Davis-Besse Nuclear Power Station, Unit No. 1
Docket No. 50-346, License No. NPF-3
Pressure and Temperature Limits Report, Revision 2

PRESSURE AND TEMPERATURE LIMITS REPORT

FOR THE EARLIER OF 32 EFFECTIVE FULL POWER YEARS OR APRIL 22, 2017

Revision 2

Figure 1: Composite Normal Heatup/Cooldown Limit – Both Hot Leg Pressure Taps

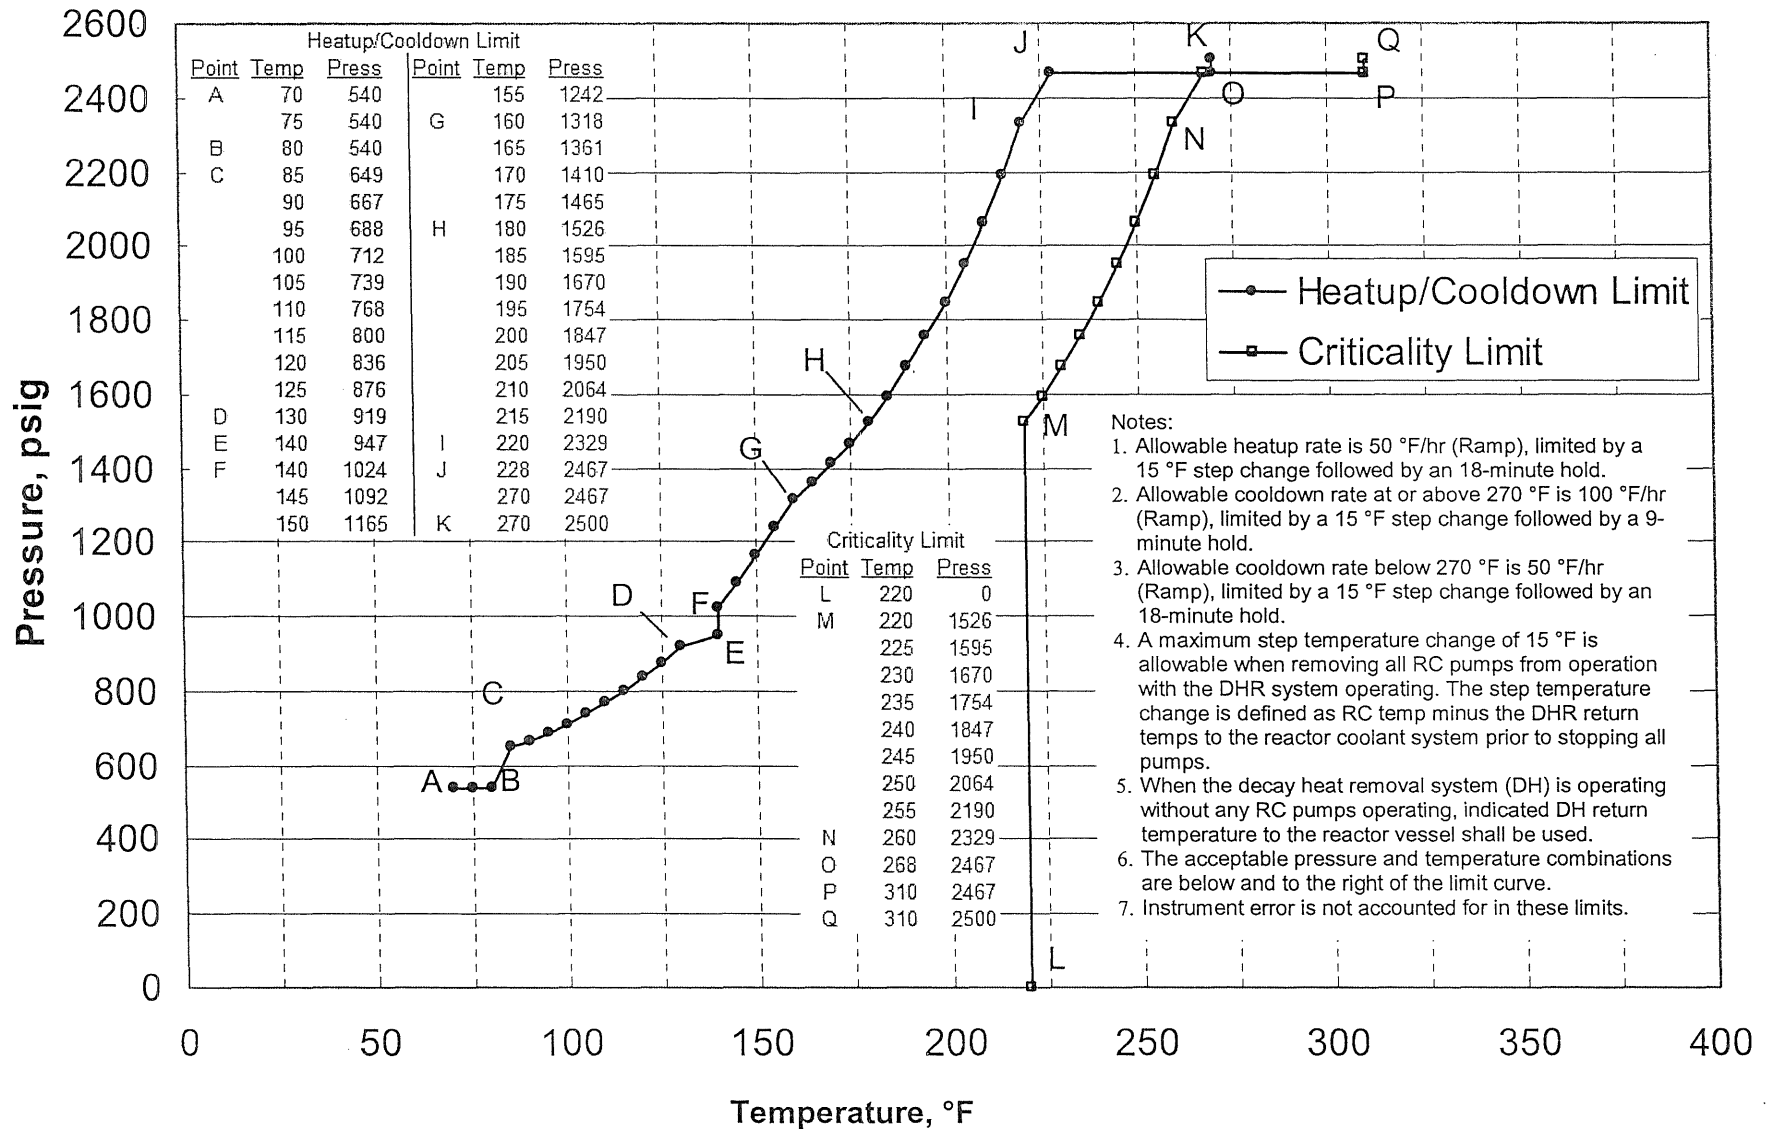
Revision 2 is re-issuing the 32 EFPY Pressure-Temperature limits to incorporate Revision 4 of ANP-2718, "Appendix G Pressure-Temperature Limits for 52 EFPY, Using ASME Code Cases for Davis-Besse Nuclear Power Station" (Reference 5.7). Revision 4 of ANP-2718 combined the Heatup/Cooldown Curves into a single Figure. This results in the re-numbering of the In-Service Leak and Hydrostatic Tests Figure to Figure 2. No methodology changes occurred in this revision.
